RENESAS TECHNICAL UPDATE

Product Category	MPU&MCU		Document No.	TN-H8*-281A/EA	Rev.	1.0
Title	Notes on Arbitration Lost in I ² C Bus Interface of the H8S Series		Information Category	Usage Limitation		
Applicable Product	H8S/2148,H8S/2138 Series H8S/2149,H8S/2169 Series H8S/2140B Series H8S/2110B H8S/2128 Series H8S/2158 Series H8S/2168 Group H8S/2194 Series H8S/2199R Series	Lot No.	Reference Document	Following Hardware Manuals: H8S/2148 Series (ADE-602-125B Rev.3.0) H8S/2138 Series (ADE-602-144B Rev.3.0) H8S/2149, 69 Series (ADE-602-190A Rev.2.0) H8S/2140B Series (ADE-602-274A Rev.2.0) H8S/2110B (ADE-602-298 Rev.1.0) H8S/2128 Series (ADE-602-114B Rev.3.0) H8S/2158 Series (ADE-602-255A Rev.2.0) H8S/2168 Group (REJ09B0078-0300Z Rev.3.00) H8S/2194 Series (ADE-602-160A Rev.2.0) H8S/2199R Series (ADE-602-232 Rev.1.0)		
		All

Figure 1 Diagram of Erroneous Operation when Arbitration is Lost

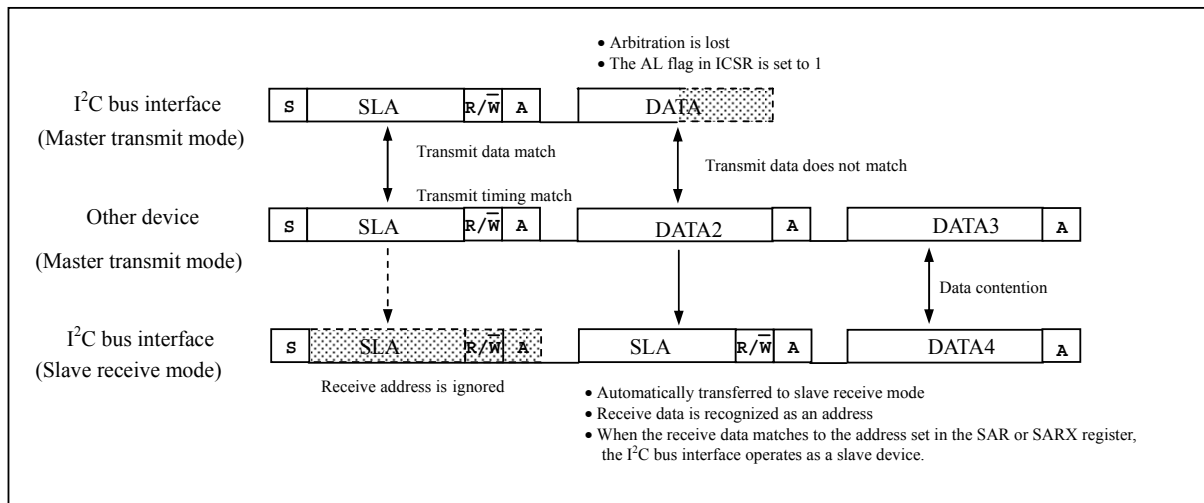
The I²C bus interface recognizes the data in transmit/receive frame as an address when arbitration is lost in master mode and a transition to slave receive mode is automatically carried out.

When arbitration is lost not in the first frame but in the second frame or subsequent frame, transmit/receive data that is not an address is compared with the value set in the SAR or SARX register as an address. If the receive data matches with the address in the SAR or SARX register, the I²C bus interface erroneously recognizes that the address call has occurred. (See figure 1.)

In multi-master mode, a bus conflict could happen. When the I²C bus interface is operated in master mode, check the state of the AL bit in the ICSR register every time after one frame of data has been transmitted or received.

When arbitration is lost during transmitting the second frame or subsequent frame, take avoidance measures.
